ALLEGHENY COUNTY SANITARY AUTHORITY

CONTRACT NO. 1735 G, E, H, P

ALCOSAN PARKING GARAGE

ADDENDUM NO. 1

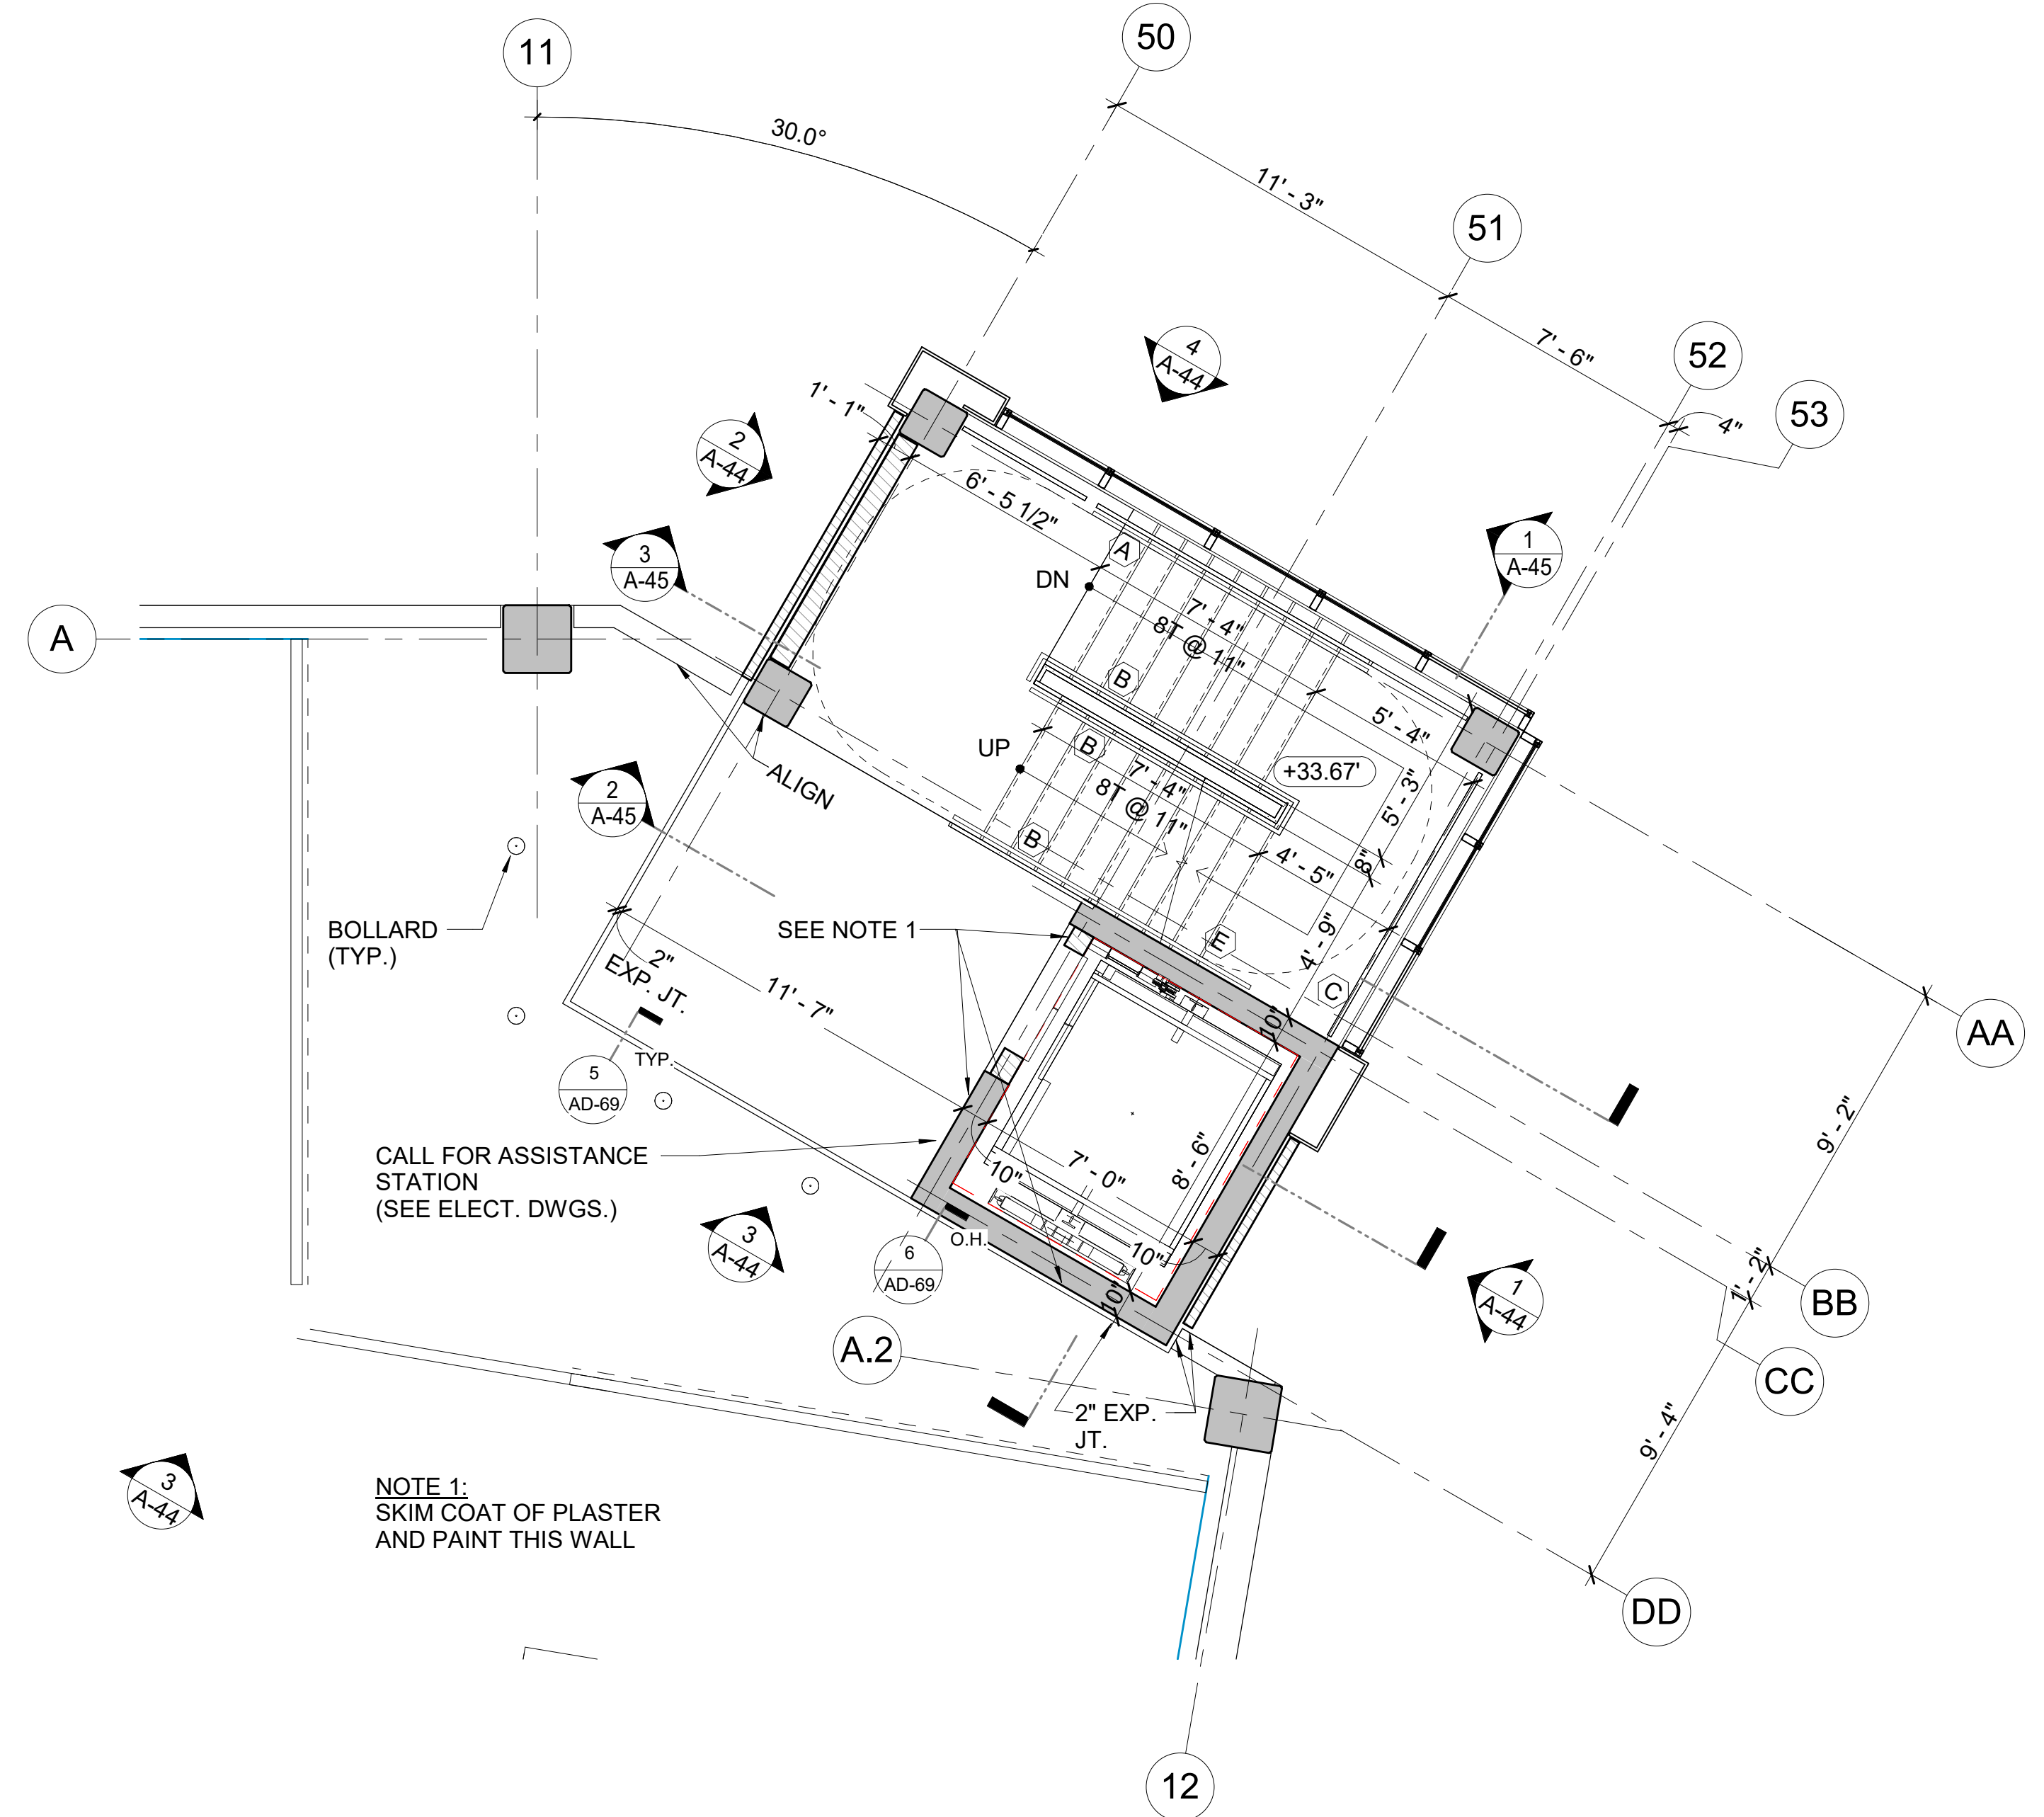
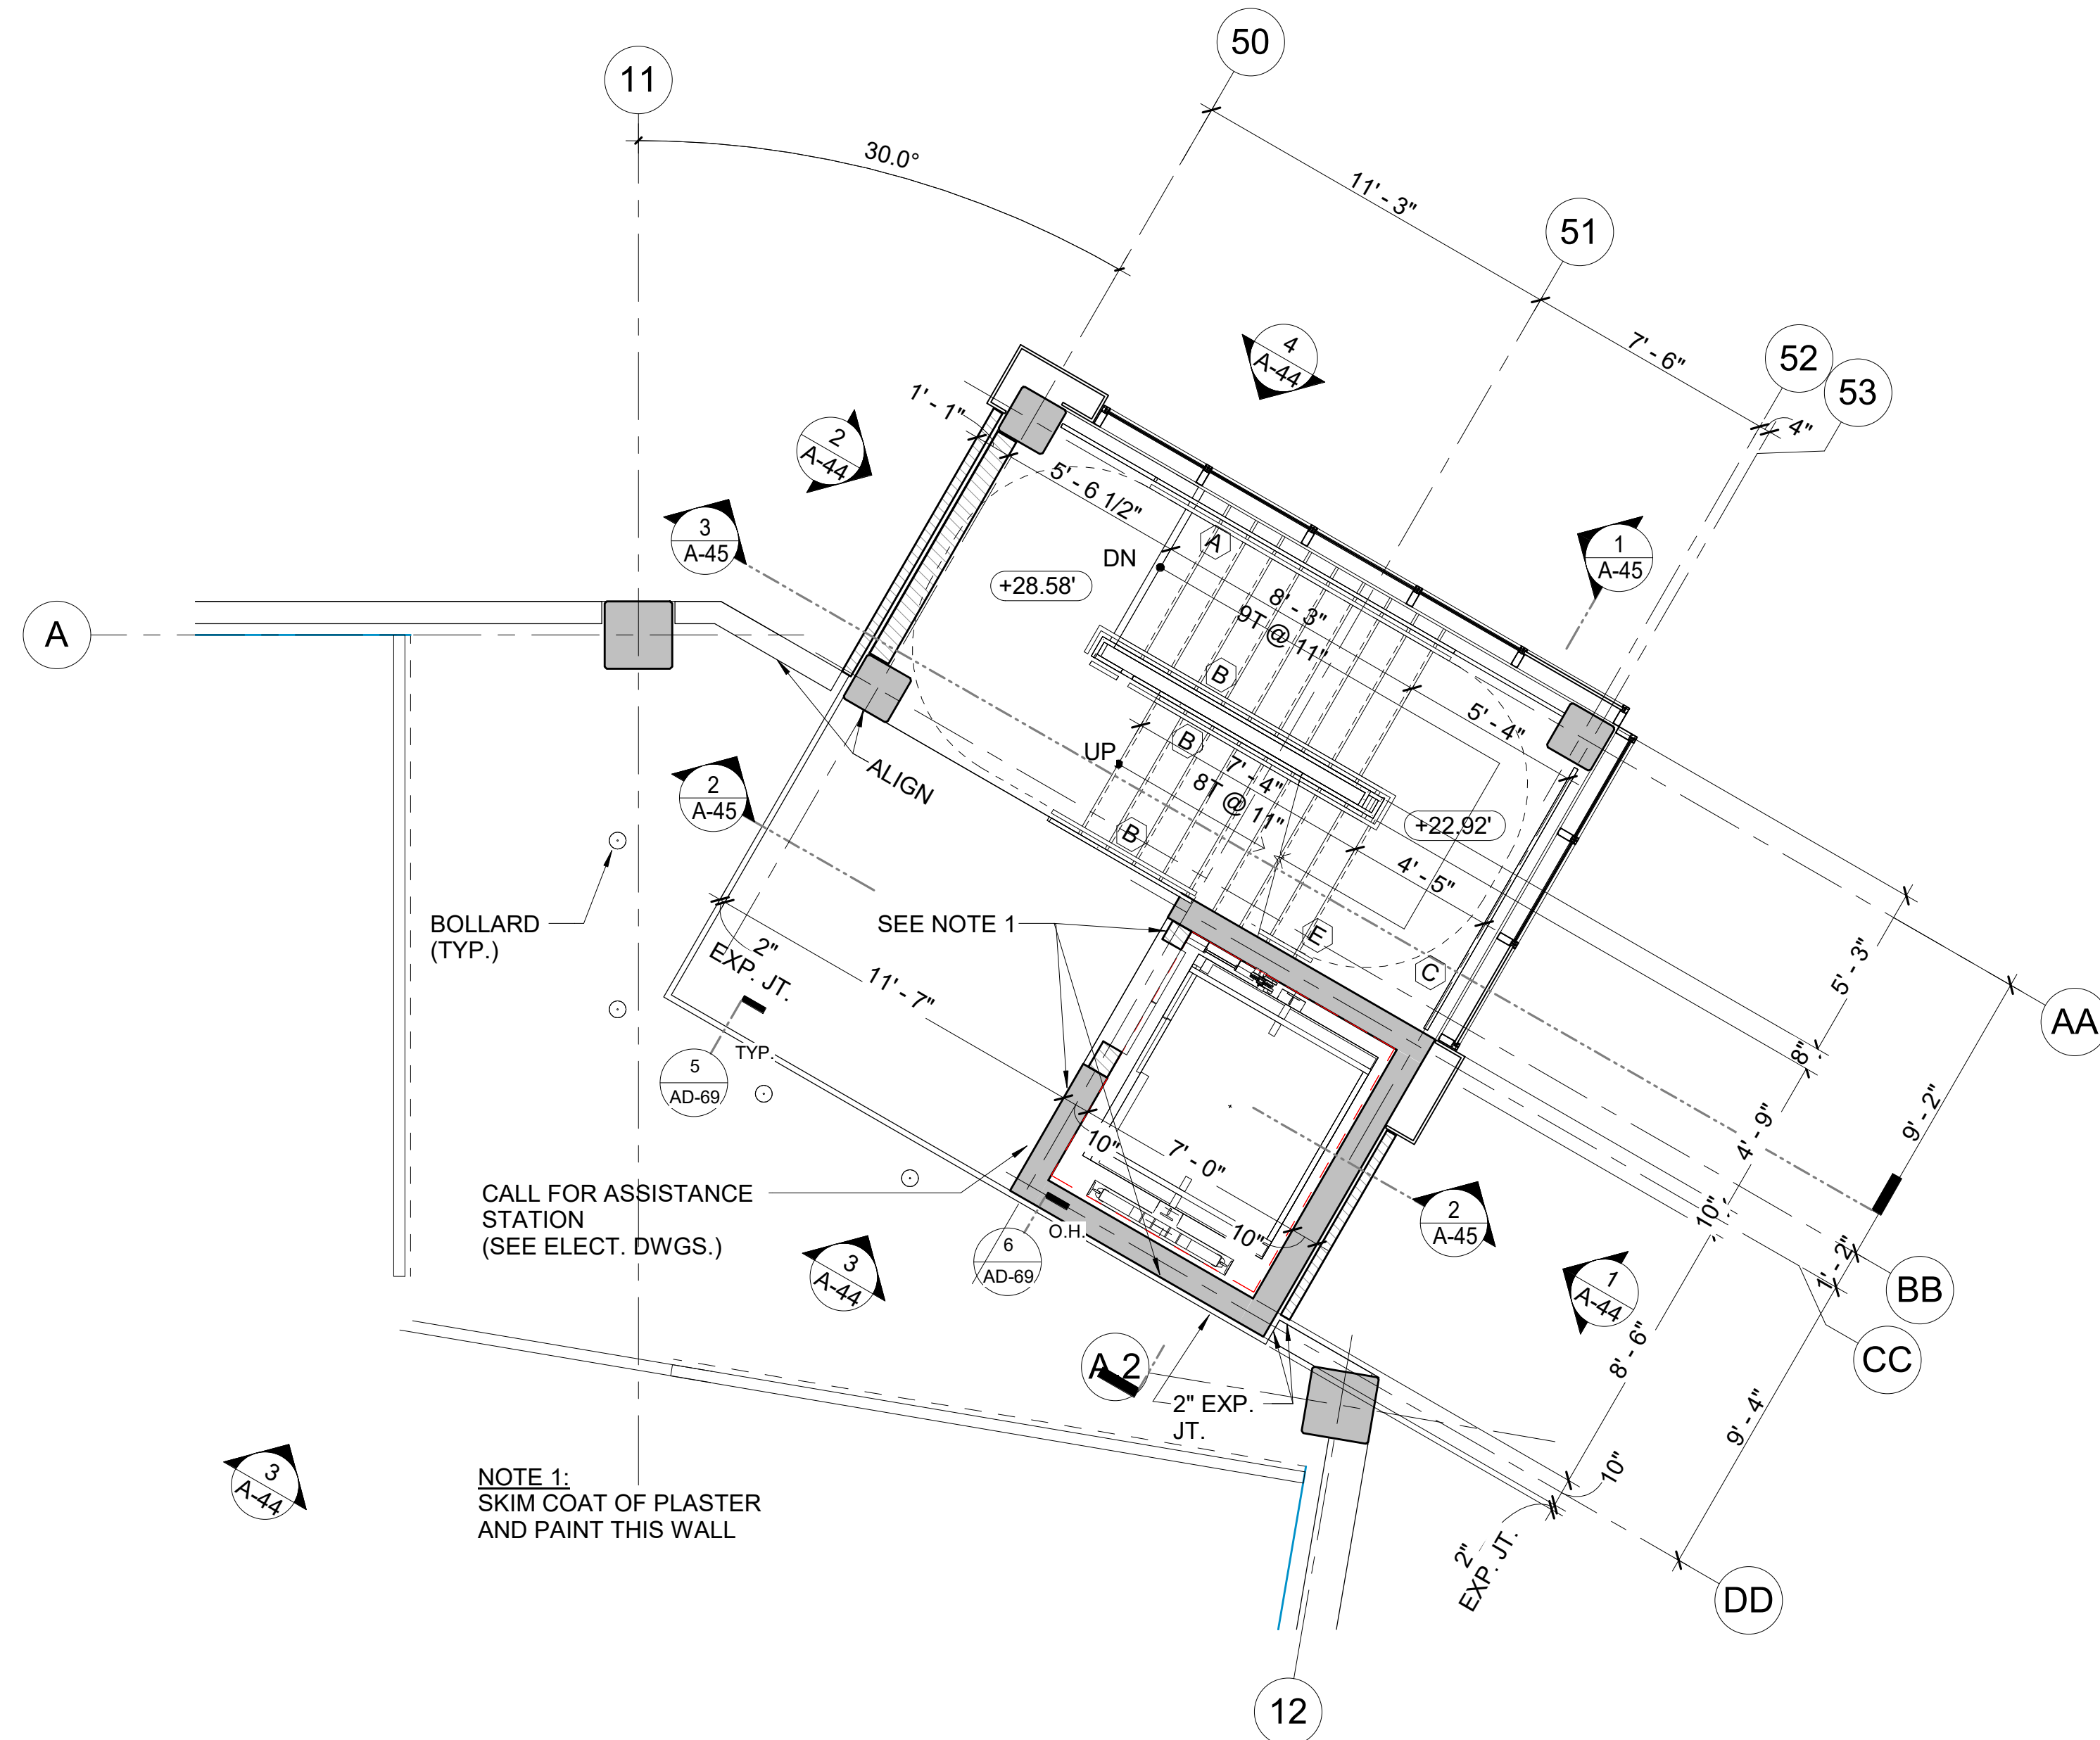
3. Drawing 210-A-41 Stair 1/Elevator – Enlarged Plans:
 - a. ADD:
